## 8 PRODUCTS CHANGE NOTIFICATION (PCN)

<b>PCN#</b> WPC-191213-001	Issuing Date	Dec 13 <sup>th</sup> , 2019
----------------------------	--------------	-----------------------------

Product Name	Description	Supplying Schedule
WIZ750SR-TTL/232/485 WIZ750SR-100/105/110 W7500S2E/W7500P-S2E	F/W 1.2.4 →1.2.9 →1.3.3	Dec 13 <sup>th</sup> , 2019

### Reason

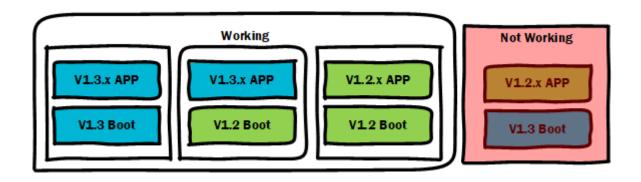
Fixed the addresses of all interrupt handlers to static addresses

With F/W Ver 1.2.9 and lower than, Boot copies Application ISR address map into Boot ISR address region to merge two binary codes. We eliminated copying Application ISR address map into Boot ISR address region, and raised F/W Ver to 1.3.x.

Changing the Boot Code is inevitable (v1.3 Boot)

• Please check the Boot code version before updating F/W with another one.

V1.2 Boot + V1.2.x App : Working

V1.2 Boot + V1.3.x App : Working

V1.3 Boot + V1.3.x App : Working (We recommend this pair)

V1.3 Boot + V1.2.x App : Not Working
